UNITED STATES PATENT AND TRADEMARK OFFICE

Office Action Summary

10/737,019

This is the **Final Office Action** for application number 10/737,019 Base Support for Post or Other Upright, filed on 12/16/03. Claims 1-6, 8, 11-20, 22-25, 27-30, 32-36 are pending. This **Final Office Action** is in response to applicant's reply dated 6/20/05. The text of those sections of Title 35, U.S. Code not included in this action can be found in a prior Office action.

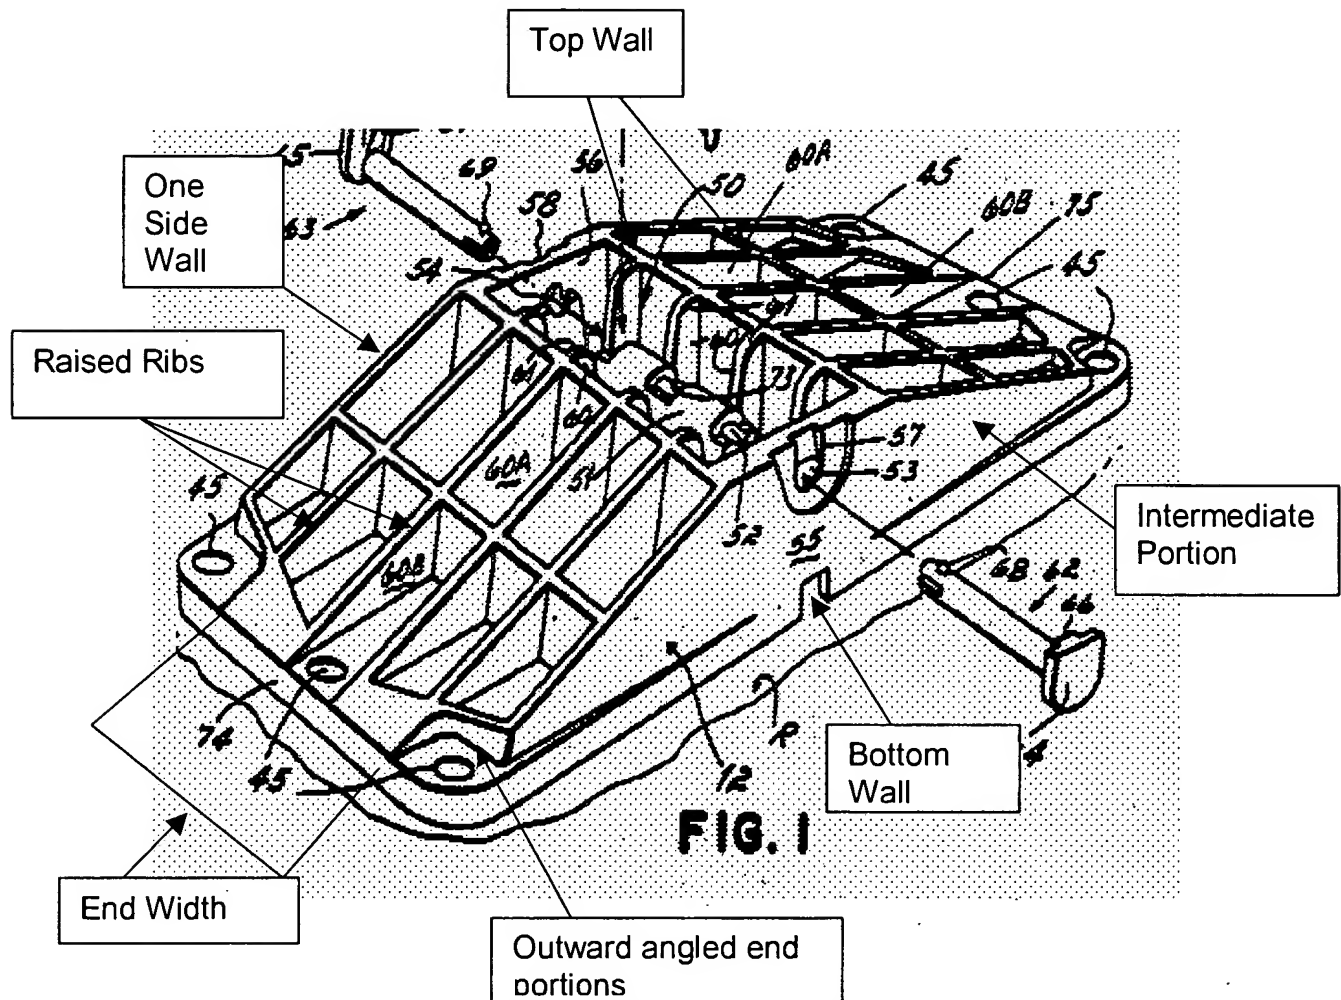
The patent to Mariol et al. teaches a molded plastic base support (See Col. 4 lines 39-45 and Col. 5, line 53, for material) for supporting an elongated member in a substantially upright position having a base member (10) having a greater length than width and spaced apart bottom and top walls and opposite side walls (55), one of the side walls being substantially straight and in substantially the same plane throughout its length, and the other of the side walls having an intermediate length that is spaced further from the plane of the one side wall than end lengths of the other side wall to provide the base member with a at least doubly wider intermediate width than end widths, and a substantially square non-circular cross-sectional shaped mounting hole (50) extending through the top wall in the wider intermediate width, the mounting hole having a width that extends widthwise inwardly and outwardly of the end lengths of just the other side wall and less than the intermediate width of the base member, wherein the end walls are in substantial alignment with each other in a parallel spaced relation from the one side wall and the mounting hole has a center that extends in a direction substantially perpendicular to an intermediate length of the top wall and is substantially in the same plane as the end lengths of the other sides wall which is substantially perpendicular to the intermediate length of the top wall. There is a horizontal plane that passes through the mounting hole center and through all the end lengths. Mariol et al. also discloses wherein the intermediate length of the other side wall has outwardly angled end portions adjacent opposite sides of the mounting hole extending toward each other and an intermediate portion extending between the end portions in parallel spaced relation to one side wall.

Mariol et al. also discloses wherein the mounting hole has a plurality of laterally spaced longitudinally extending ribs (60) around the entire periphery of the mounting hole that are axially transversely rounded and wherein the top wall has a plurality of axially spaced apart stacking ribs (See Drawing Above) and the bottom wall has corresponding recesses (89, 90) for receipt of the stacking ribs.

Mariol et al. and Stagl et al. teach the basic inventive concept including wherein Mariol et al. teaches wherein the base member has thinned out non-hollow solid end portions and wherein the top wall of the ends portions has raised ribs (See Drawing Above) to provide increased strength at the end portions. Mariol et al. and Stagl et al. do not teach wherein annular anti-skid pads the pads having a diameter greater than the width of the end portions and are attached to the bottom wall end portions.

The applicant has argued that the side walls do not meet the limitation of having one substantially straight and substantially in the same plane and having one with an intermediate length that is spaced further from the plane of the one side wall than end lengths of the other side wall. This is unpersuasive in that the term substantially means that the device had to "primarily" read on the limitation and Mariol et al. does this. The first side wall is considered the opposite of (55) which is substantially straight and in the same plane, the other side wall is the tapered portions of the ends which are substantially straight and the intermediate length is considered portion (55) as clearly indicated in the marked figure above.
